**RE: Westgate Community Center  
10001 DeVargas Rd SW  
Conceptual Grading and Drainage Plan  
Engineer's Stamp Date: 12/7/18  
Hydrology File: M09D030**

Based on the submittal received on 12/7/18, the Grading and Drainage Plan is approved for Site Plan for Building Permit.

Re: Westgate Community Center: M09D030  
COA Hydrology Site Plan for Building Permit Approval Re-Submittal

**OVERALL GRADING AND DRAINAGE PLAN**

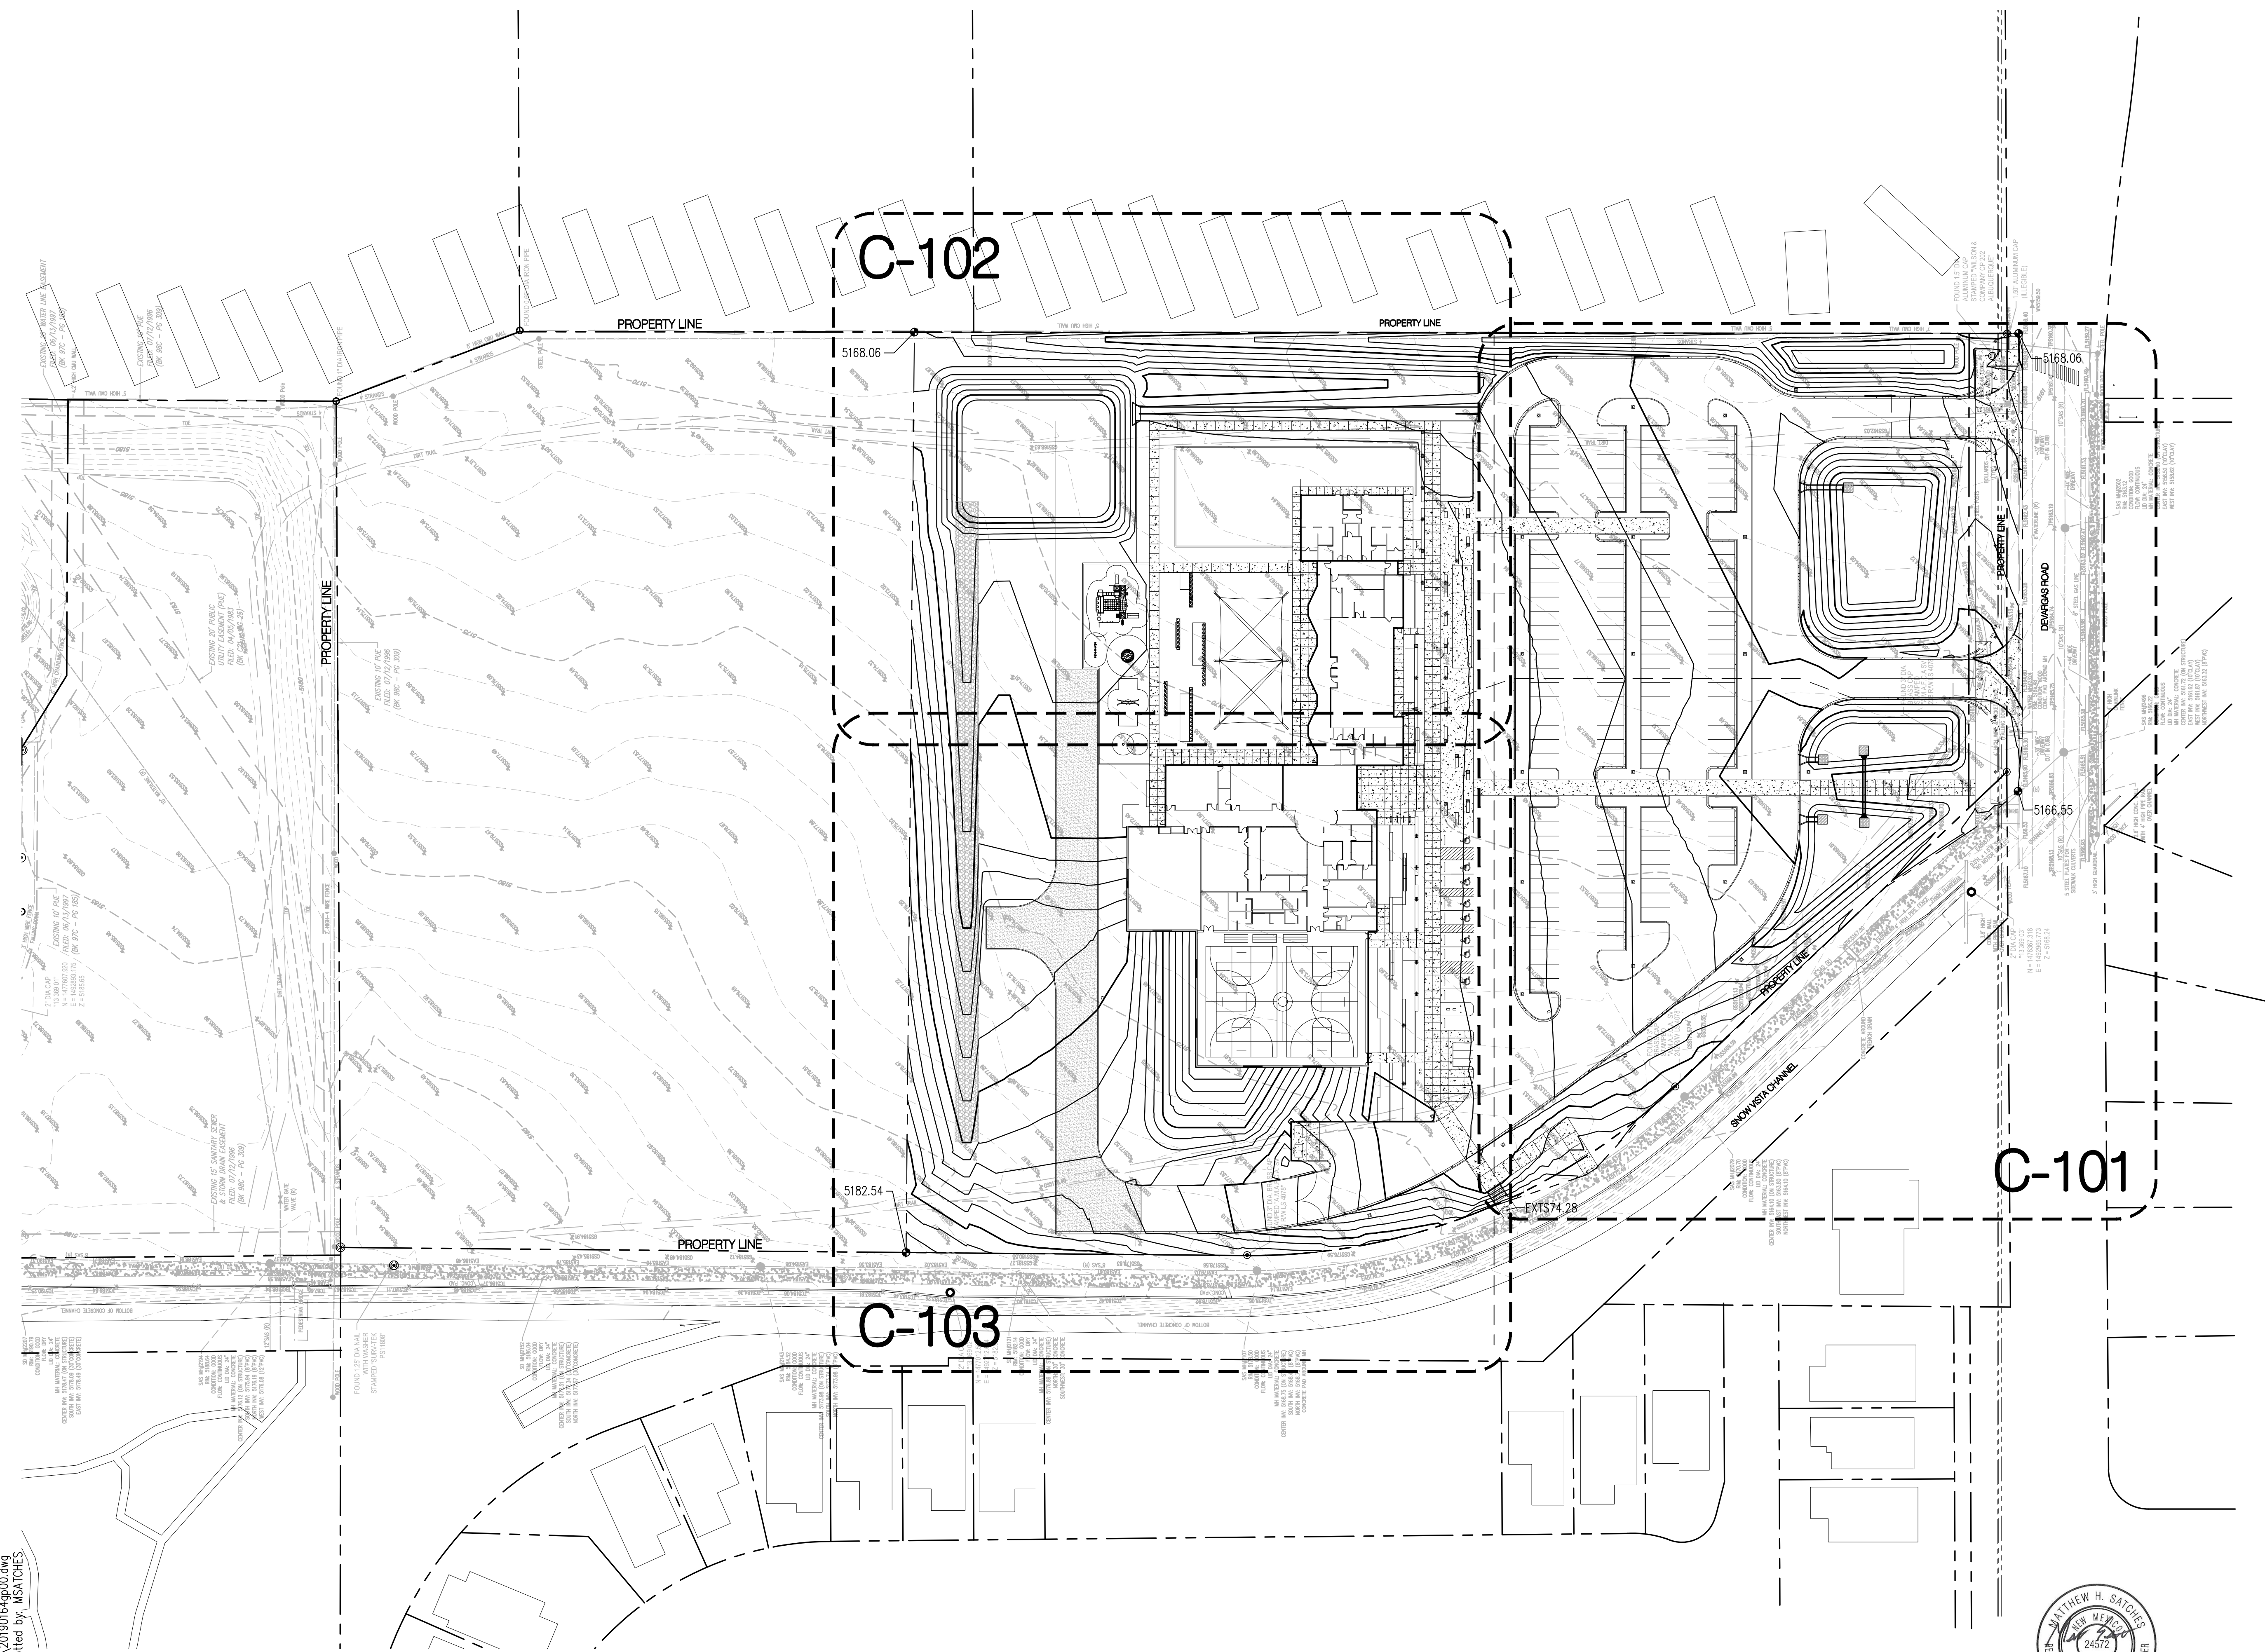
1. Provide hydraulic calculations for the riprap swale along the north side of the project and the concrete rundowns into ponds 2 and 3.
2. Include a note that *no work shall be allowed in the public ROW without an approved Work Order.*
3. Will the basin B-2 area be used for staging? It needs to be reseeded if so; specify reseeding per section 1012 for all disturbed areas.
4. Depress the landscaping in the parking islands to provide additional water quality and allow water to enter the islands instead of ponding/ backing up in the parking spots.
5. Remove all "Conceptual" markings.
6. Additional comments may be provided at Building Permit, based on the outcome of the above remarks and level of detail shown on plans.

PROJECT ARCHITECT: LEE GAMESKY, AIA	Project #: Date: 13 DECEMBER 2018
SITE DEVELOPMENT PLAN FOR BUILDING PERMIT DRB PROJECT NO.:	
GRADING AND DRAINAGE - SOUTH	
By: JPW	Sheet: Of:
SITE DEVELOPMENT PLAN	
C-101

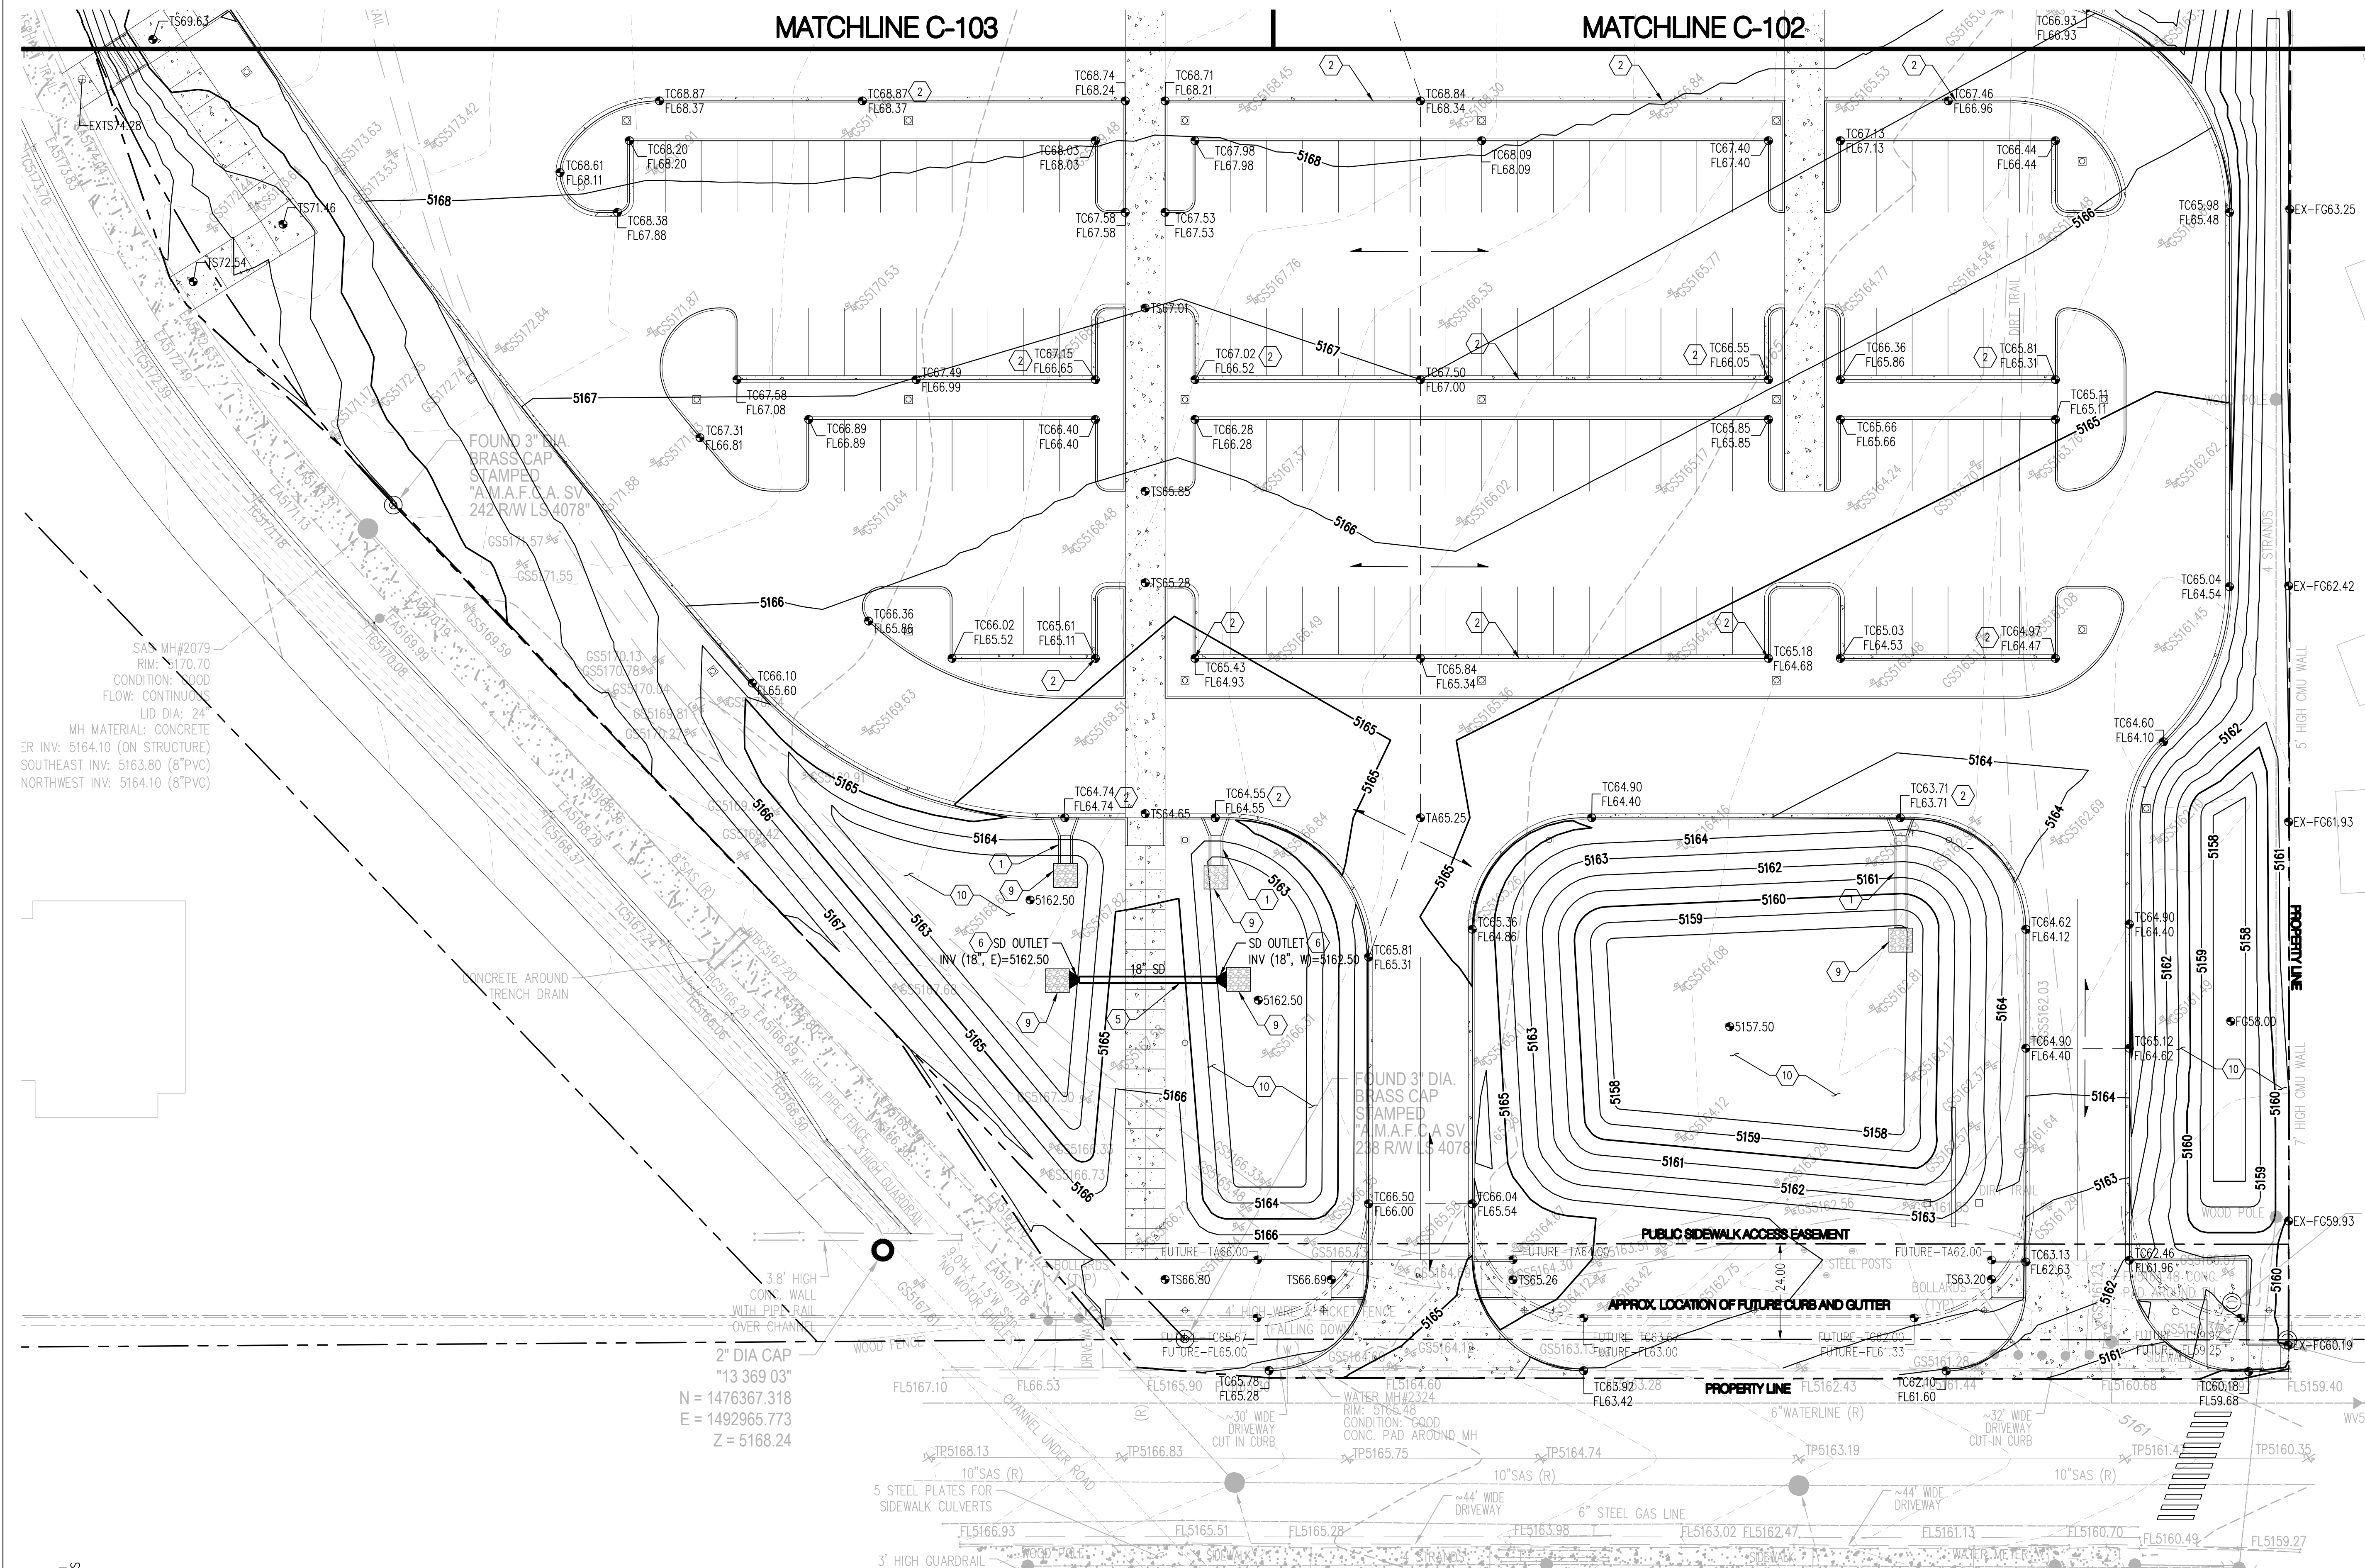
1. Standard Drawing 2260 is now referenced in the concrete ribbon channel keyed note.
2. The Pond 4 Emergency Spillway has been removed.
3. The grading in the SE corner has been updated (including the 5160 contour).
